**RESOLUTION CONTINUING HEARING ON REQUEST FROM 50TH AND DOUGLAS, LLC
TO REZONE PROPERTY IN THE VICINITY OF 3905 50TH STREET**

Communication from the City Plan and Zoning Commission advising that at their August 2, 2018 meeting, the following action was taken regarding a request from 50th and Douglas, LLC (developer), represented by Matt Connolly (officer) to rezone property located in the vicinity of 3905 50th Street from "R1-60" One-Family Low-Density Residential District to "PUD" Planned Unit Development for development of 21 row house 1-story townhomes on a private drive accessed from 50th Street. Subject property is owned by Penny Meyer and Jerry Lohner.

STAFF REPORT TO THE PLANNING COMMISSION

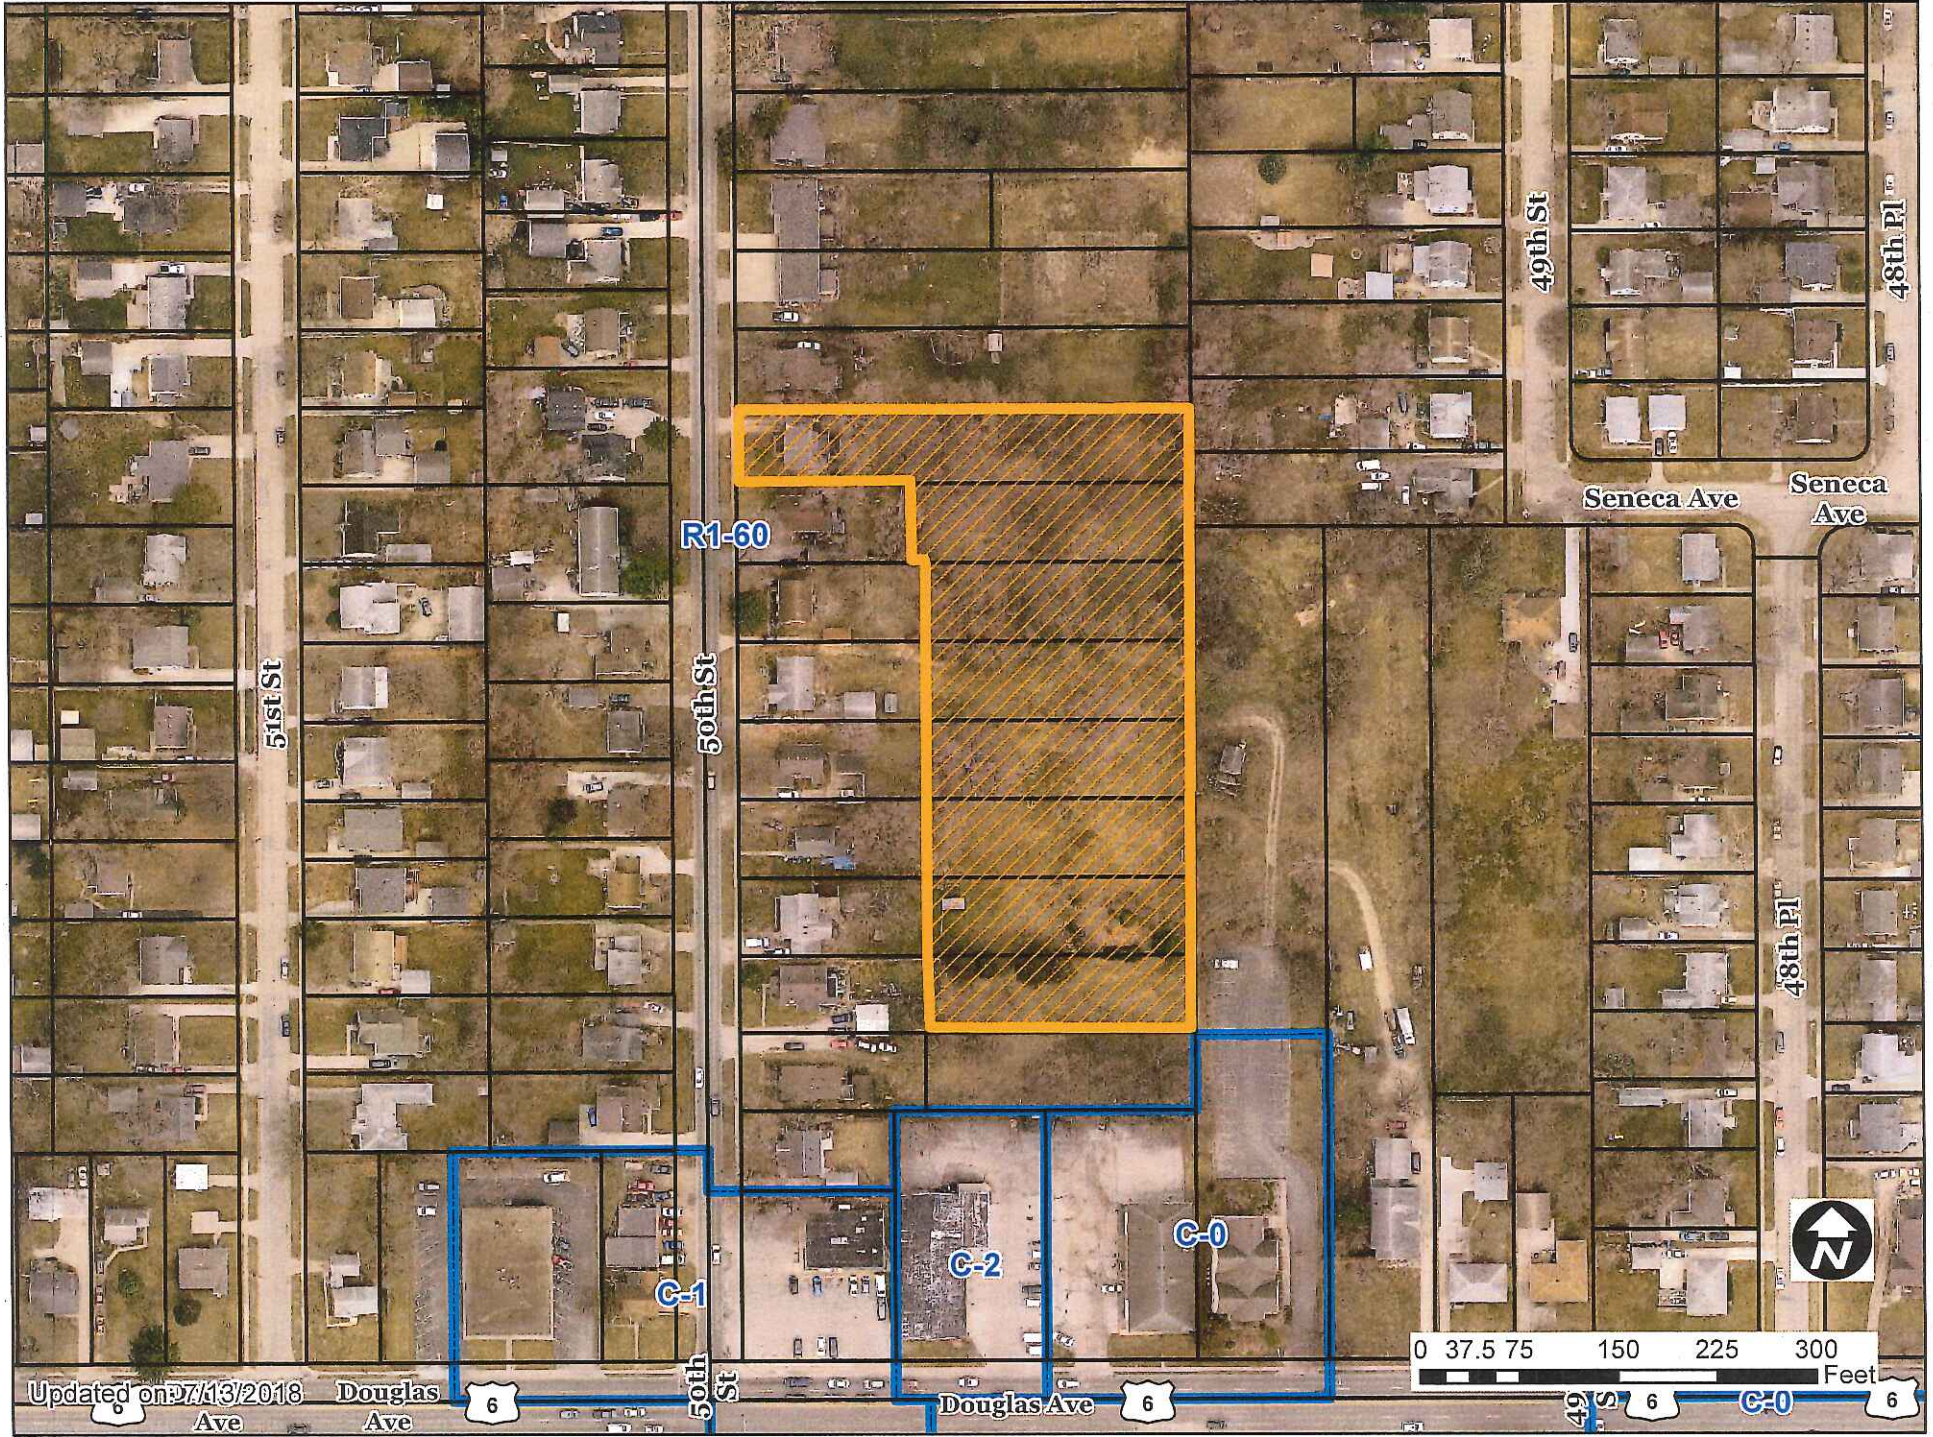
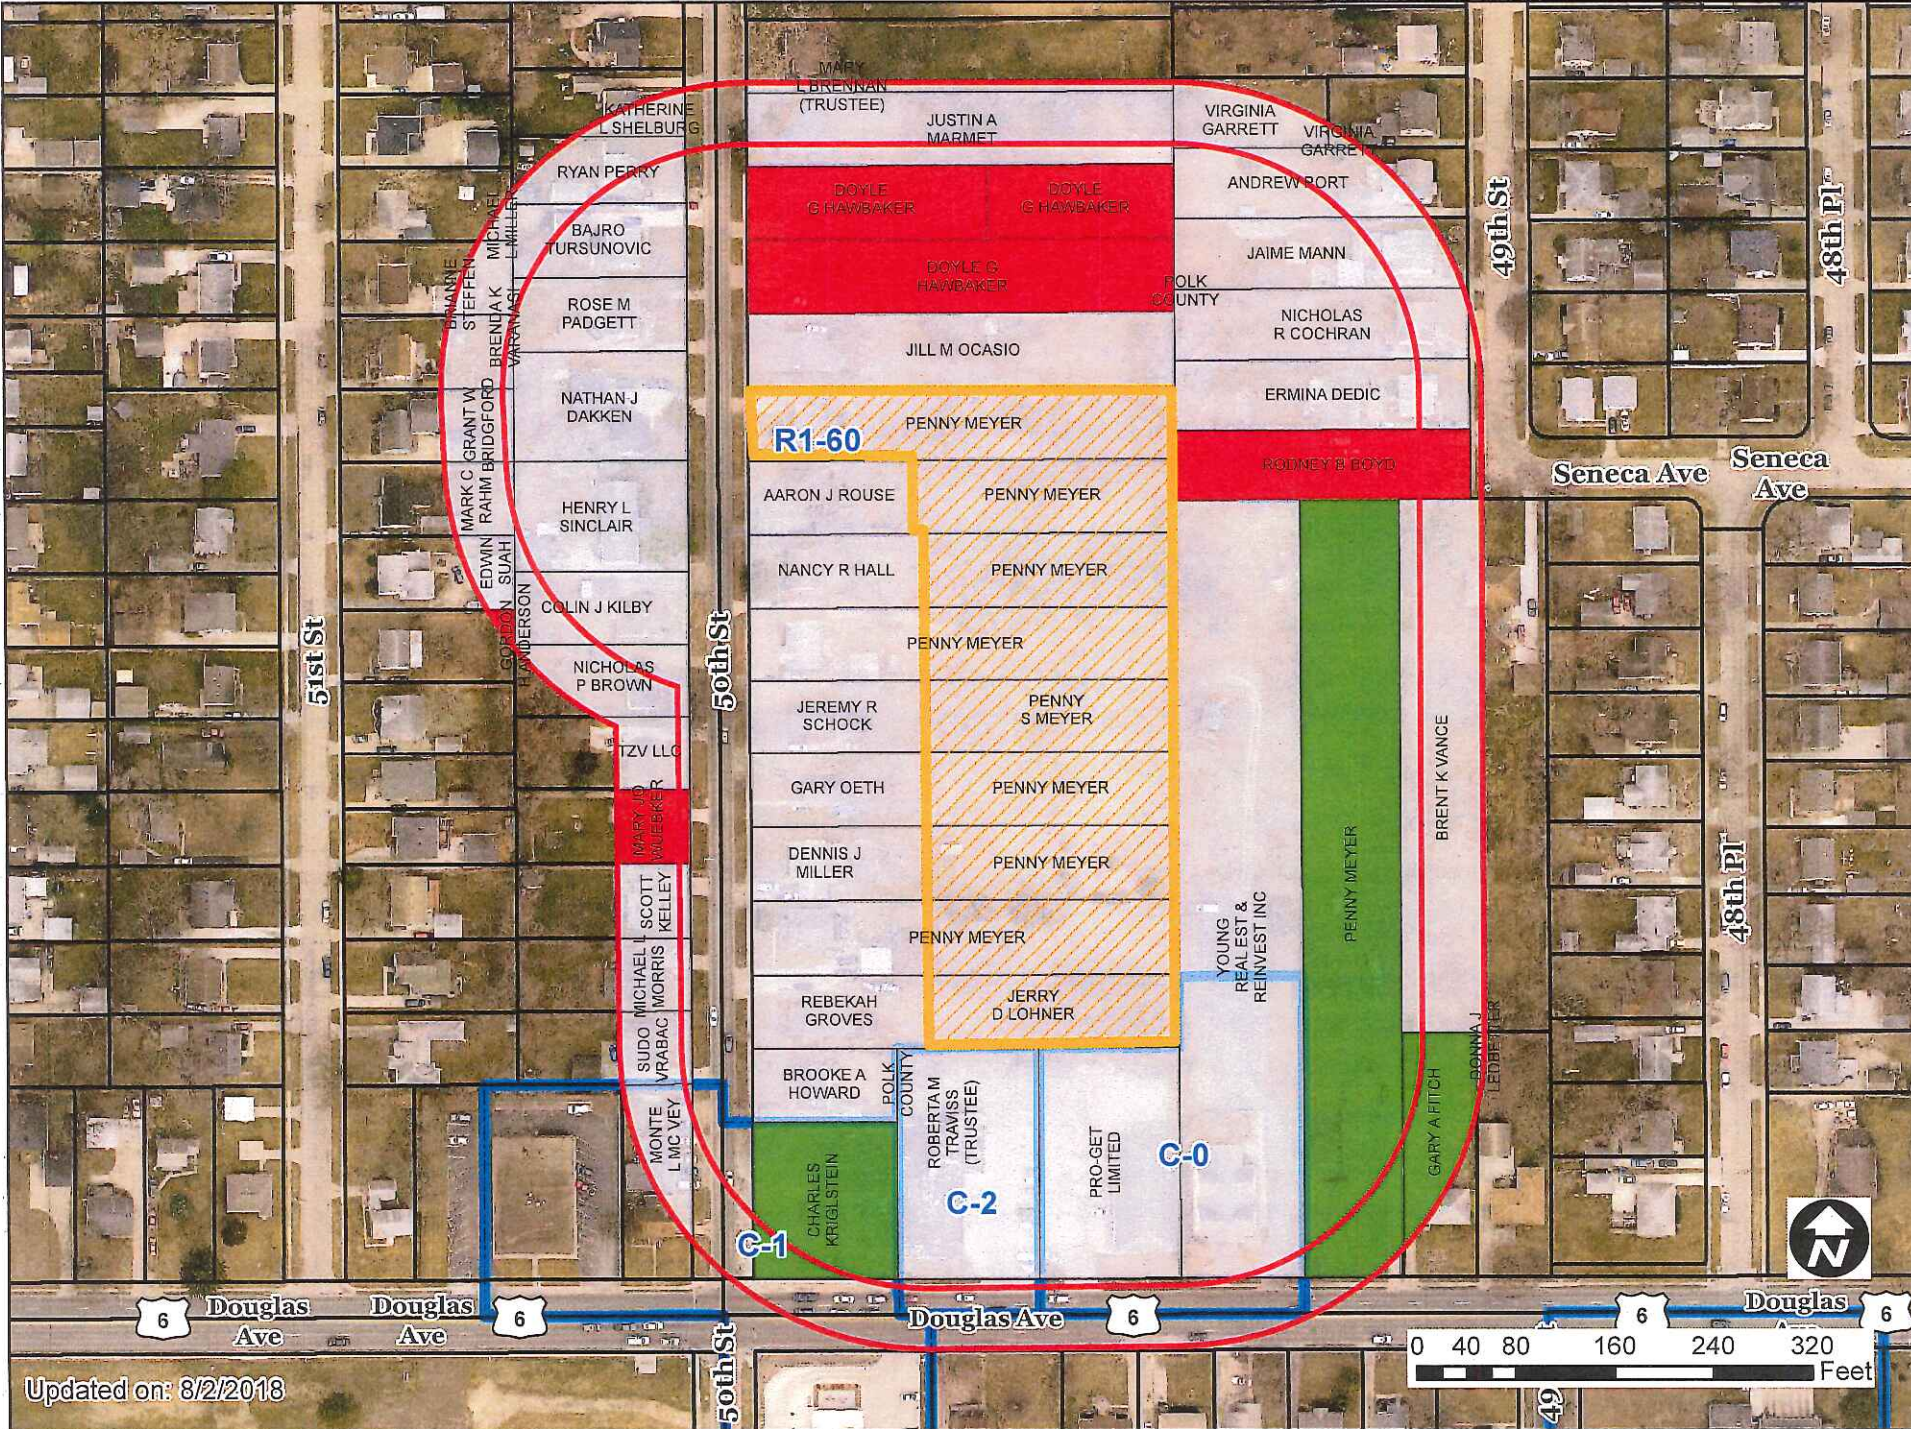
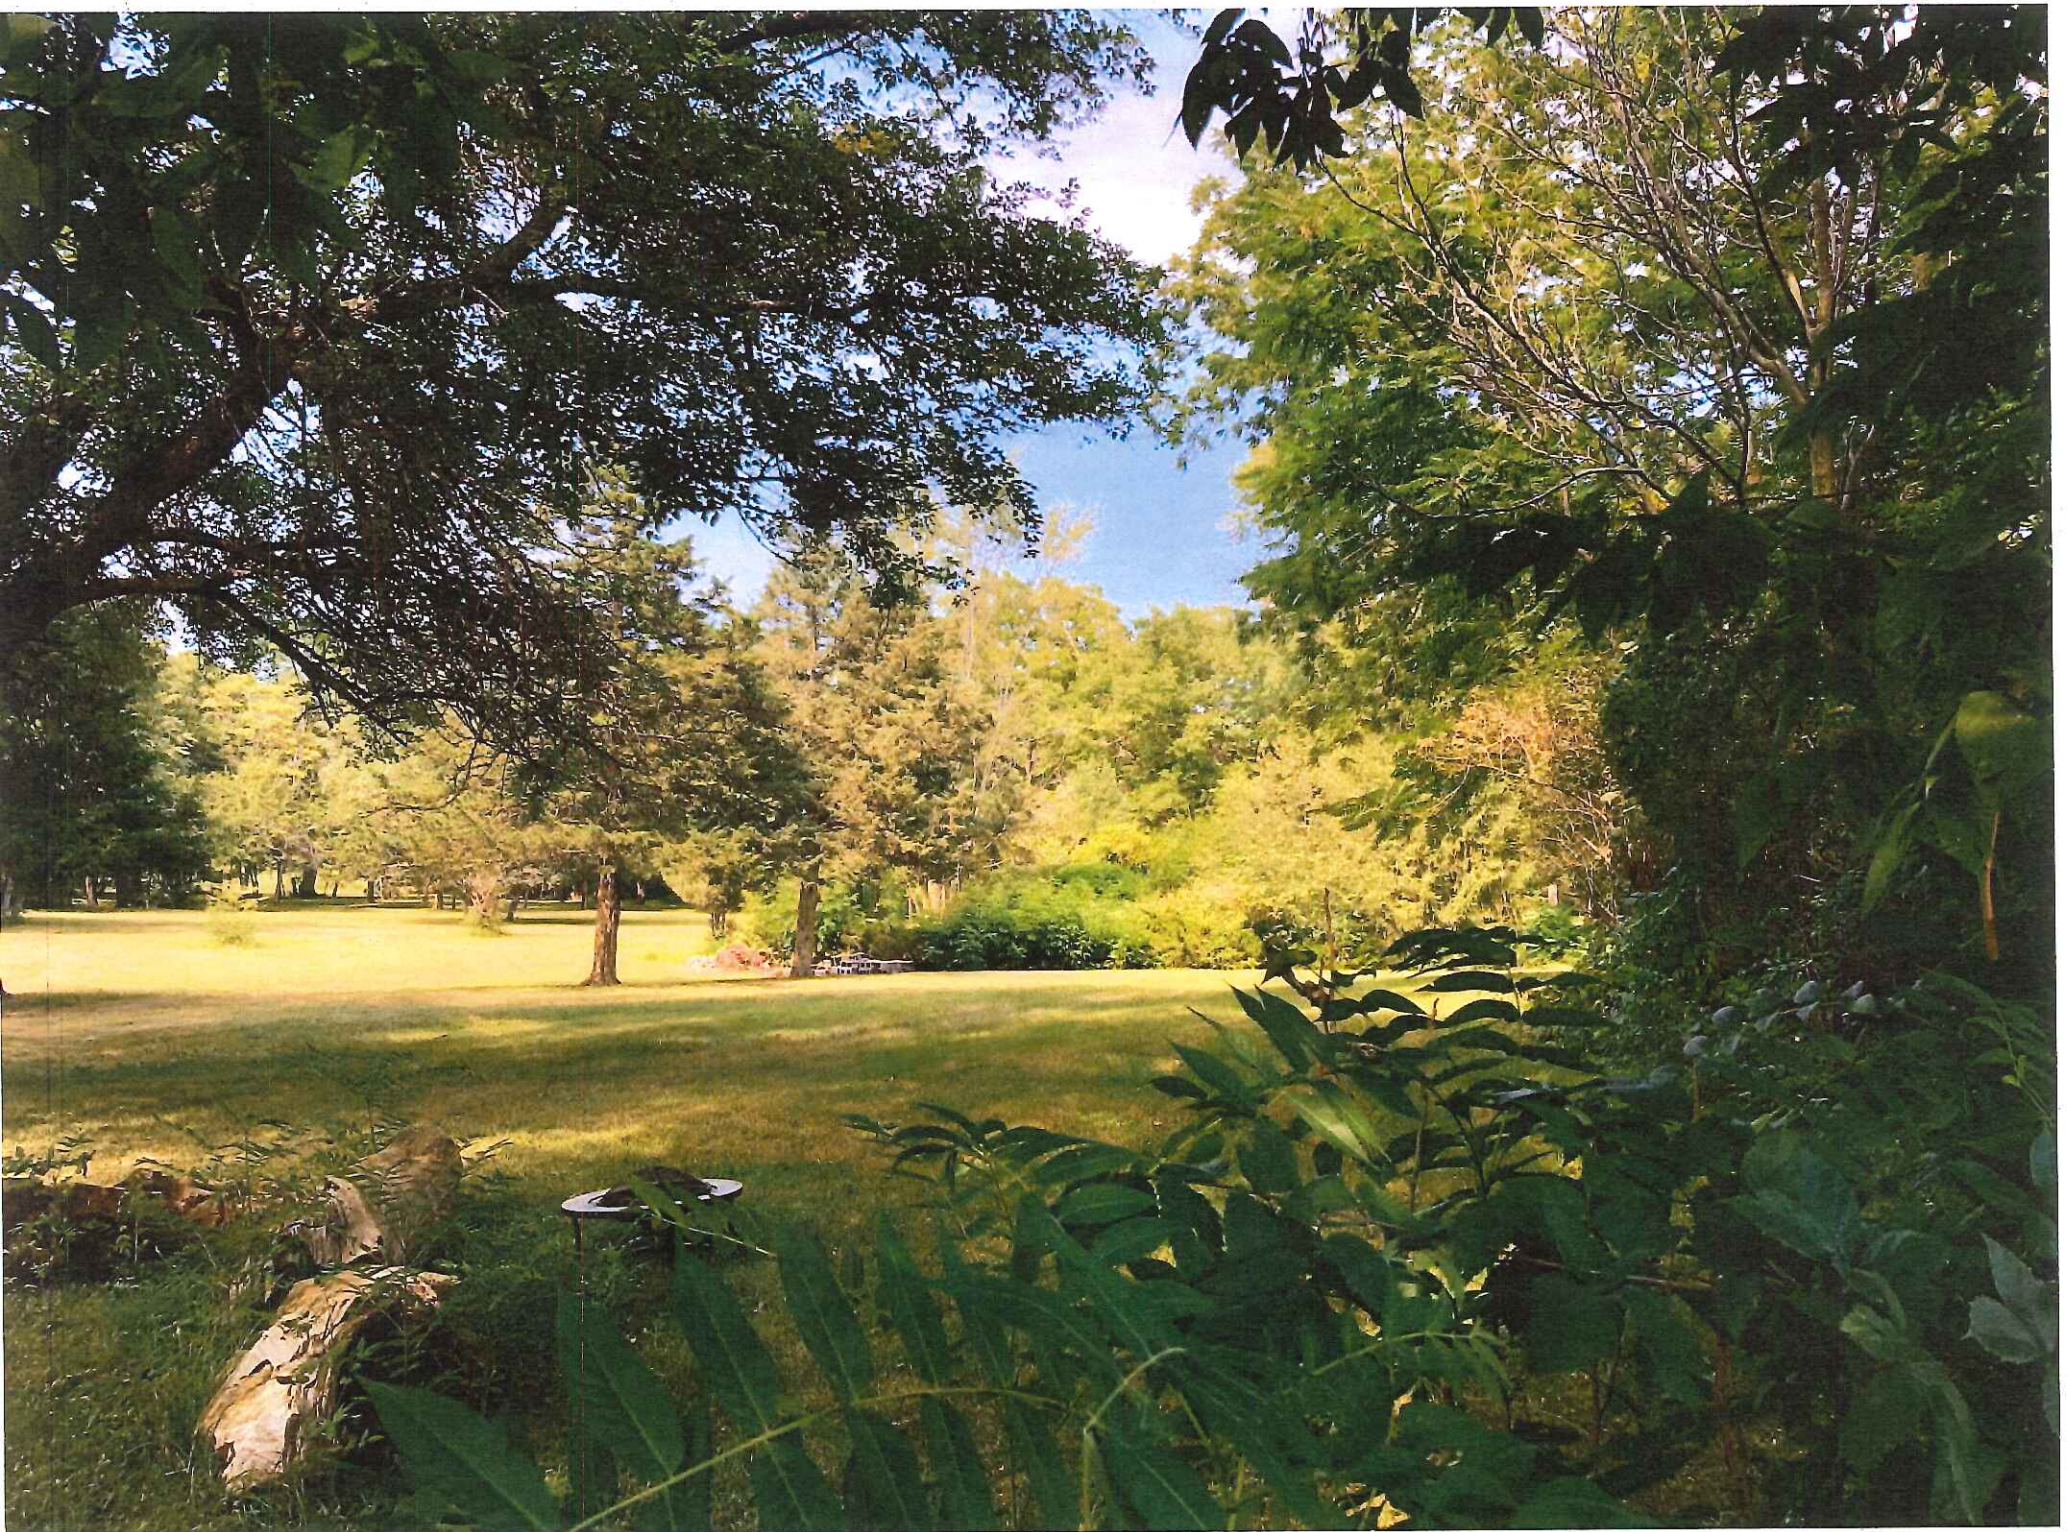
The PUD Conceptual Plan includes a storm water basin in the northeast corner of the development. A swale is noted along the west perimeter of the development to move storm water to the basin. Staff believes that raingardens should be provided along the access drive to capture run off from the pavement and roofs of the buildings as well as to soften the high percentage of pavement and rooftops that are proposed for the development. Section III of this report includes the recommendation that the sidewalks be separated from the access drive a distance of at least 4 feet and that raingardens/swales be provided in that space.

- *This concept plan indicated existing public storm sewer will be relocated with existing easements being vacated. New public storm sewer locations on private property will need to be within a 30-foot minimum easement.*

- *The concept indicates “swales” along the east and west property lines within a 10-foot minimum setback. A 10-foot width is very small for a grassed swale with this size of drainage area. The designer will need to provide evidence that swales can convey 100-yr storm event.*

The staff recommendation found in Section III of this report includes a condition that the driveways be reduced in width from 26 to 20 feet per unit. This would leave enough space for two vehicles to park by each other. The development as proposed includes a substantial amount of pavement given the limited area available for green space due to the size of the parcel. This recommended condition balances the need for parking with the goal of providing greenspace and minimizing the amount of impervious surfaces on the site.

12. Raingardens, bio-swales, landscaping and/or detached sidewalks shall be provided to visually break up paved surfaces through the center of the development to the satisfaction of the Planning Administrator.

23. A 4-foot detached sidewalk shall be provided on the west side of the private drive only.
